設工認その 13 に係る内部火災に対する原子炉停止後 30 秒の冷却の確保について

令和 2 年 8 月 25 日

日本原子力研究開発機構

【R2. 7. 21 コメント】

図1 防護対象ケーブルの敷設状況

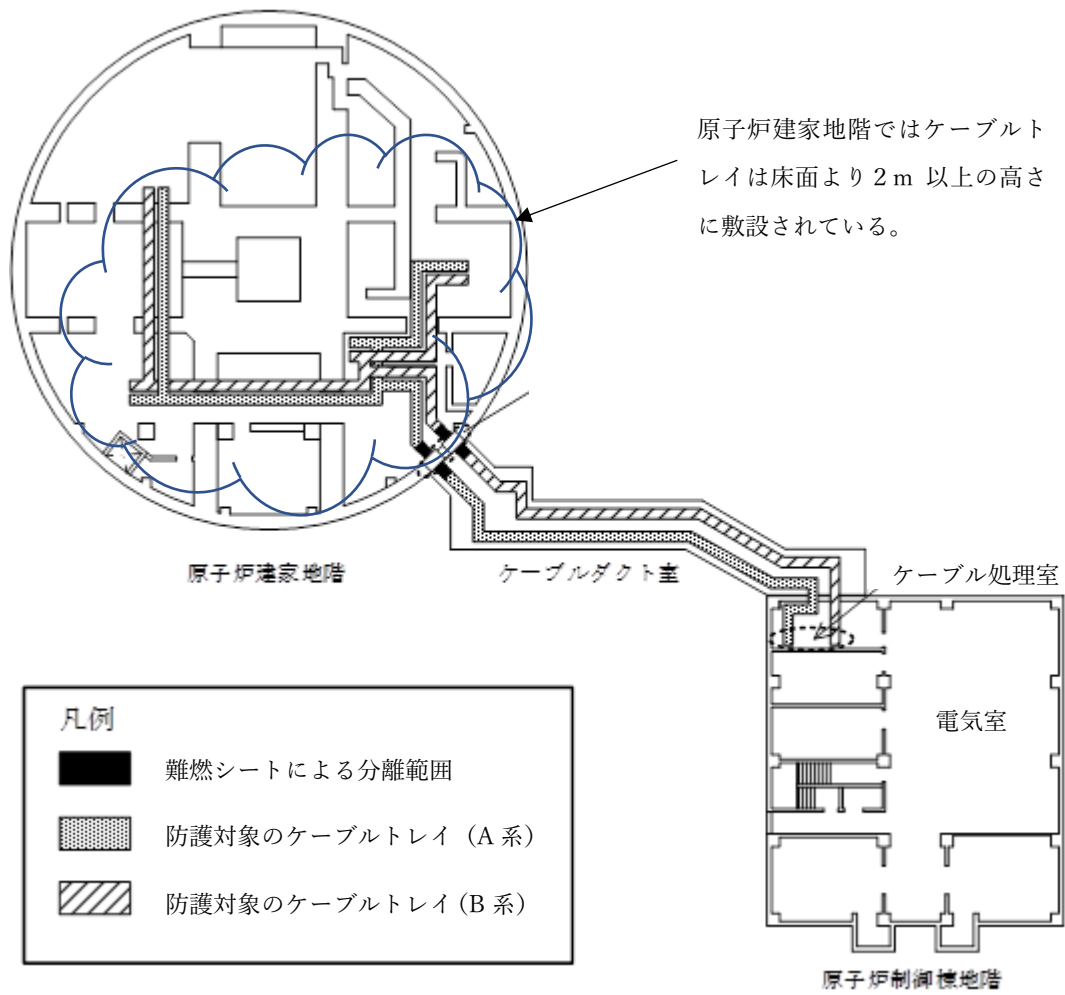
一般的なデータ等で構わないので、この分離により原子炉停止後 30 秒の冷却を確保できることを説明すること。

原子炉建家地階において防護対象のケーブルは床面から 2m 以上の高さに敷設されている（図 1 参照）。原子炉建家については、発火性物質及び引火性物質の持込を管理しており、原子炉建家内にそれらを保管する場合には金属製の容器に収納している。また、原子炉建家地階には実験利用設備はなく、運転員以外の立入を禁止している。加えて、原子炉建家地階は運転員による 1 日 3 回の巡視を実施している。以上の状況を踏まえ、火災源については運転員が使用する巡視記録等の紙類を想定し、NUREG/CR-6850 の Final Report^{*2}における仮置可燃物の燃焼試験の結果から表 1 の通り選定する。最も厳しい条件として、これらの仮置可燃物が高さ 2m に敷設されたケーブルトレイの直下において発火した場合のケーブルへの影響を評価する。
